City of Phoenix
PLANNING AND DEVELOPMENT DEPARTMENT

Staff Report Z-74-24-6
July 26, 2024

Request To: [R-5](#) (Multifamily Residence District) (1.82 acres)

Location: Northeast corner of 21st Street and Turney Avenue

1 ARCHITECTURAL SITE PLAN
1" = 32'-0"

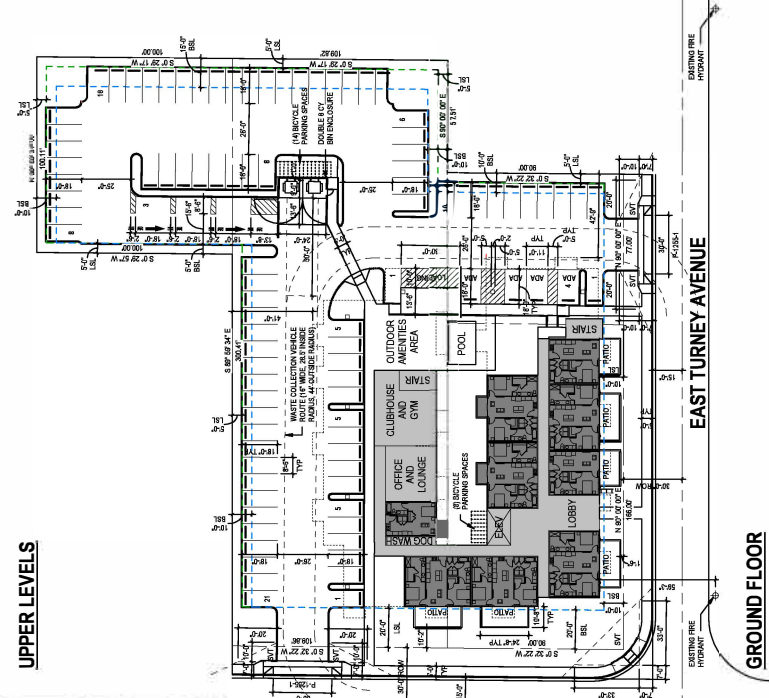
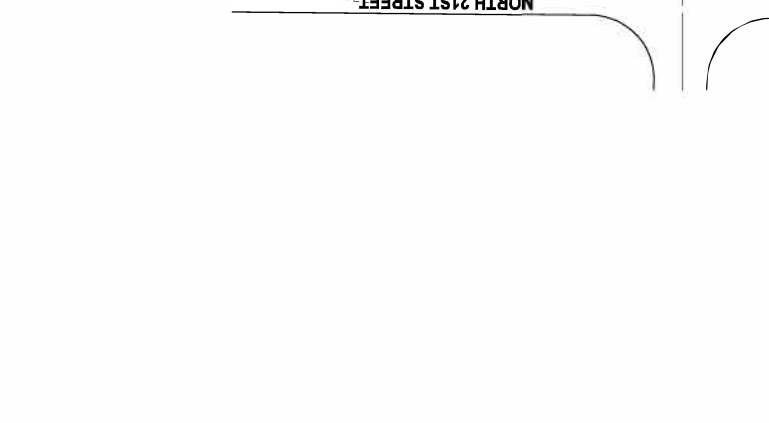
R-5 (Multifamily Residence District) Subdivision Development Option		
<u>Standards</u>	<u>Requirements</u>	<u>Site Plan Provisions</u>
Gross Acres	-	1.82 acres
Maximum Dwelling Units	79	75 (Met)
Maximum Density (dwelling units/acre)	43.5	41.21 (Met)
Maximum Building Height	4 stories or 48 feet	4 stories and 48 feet (Met)
<i>Minimum Building Setbacks</i>		
North (side)	3 feet	46 feet (Met)
East (rear)	15 feet	48 feet (Met)
West (21st Street, front)	20 feet	10 feet (Not Met*)
South (Turney Avenue, side)	10 feet	9 feet (Not Met*)
<i>Minimum Landscape Setbacks</i>		
North (side)	5 feet	5 feet (Met)
East (rear)	5 feet	5 feet (Met)
West (21st Street, front)	20 feet	10 feet (Not Met*)
South (Turney Avenue, side)	10 feet	9 feet (Not Met*)
<i>Lot Standards</i>		
Minimum Open Space	5 percent	5.26 percent (Met)
Maximum Lot Coverage	50 percent	15 percent (Met)
Minimum Parking	113 vehicular spaces	96 vehicular spaces (Not Met*)

*Site plan modification required or variance must be obtained.

- The site plan, attached as an exhibit, proposes a 75-unit multifamily residential development with an outdoor amenity area, pool, clubhouse, and gym. The site plan includes 96 parking spaces along the northern sides of the building, secured bicycle parking in the residential building and in the northeast parking lot. Full driveway access to the parking lots will be from 21st Street and Turney Avenue. Landscaping along the northern property line will include trees and shrubs to provide added buffering along the property perimeter. A detached sidewalk along Turney Avenue and an attached sidewalk along 21st Street will provide pedestrian connections to the adjacent residential developments in the area. The sidewalks will include trees for shade coverage. Due to the need to seek variances for the patio projections within the building and landscape setbacks along 21st and Turney Avenue and a reduction in parking, staff does not recommend general conformance to the site plan. Staff recommends Stipulation Nos. 1, 2, 4, and 15 to

provide an enhanced pedestrian environment, shade, and an enhanced setback along the north property lines.

1. The landscape setback along 21st Street shall be planted with minimum 2-inch caliper, large canopy, drought-tolerant, shade trees, planted 20 feet on center, or in equivalent groupings, as approved by the Planning and Development Department.
2. A minimum 40-foot building setback shall be provided along the north property lines, as approved by the Planning and Development Department.
3. A minimum 5-foot sidewalk shall be constructed on the east side of 21st Street, adjacent to the development.
4. A minimum 5-foot-wide detached sidewalk, separated by a minimum 7-foot-wide landscape area, shall be constructed on the north side of Turney Avenue. The landscape area shall be planted with minimum 2-inch caliper, single-trunk, large canopy, drought-tolerant, shade trees planted 20 feet on center, or in equivalent groupings, as approved by the Planning and Development Department.
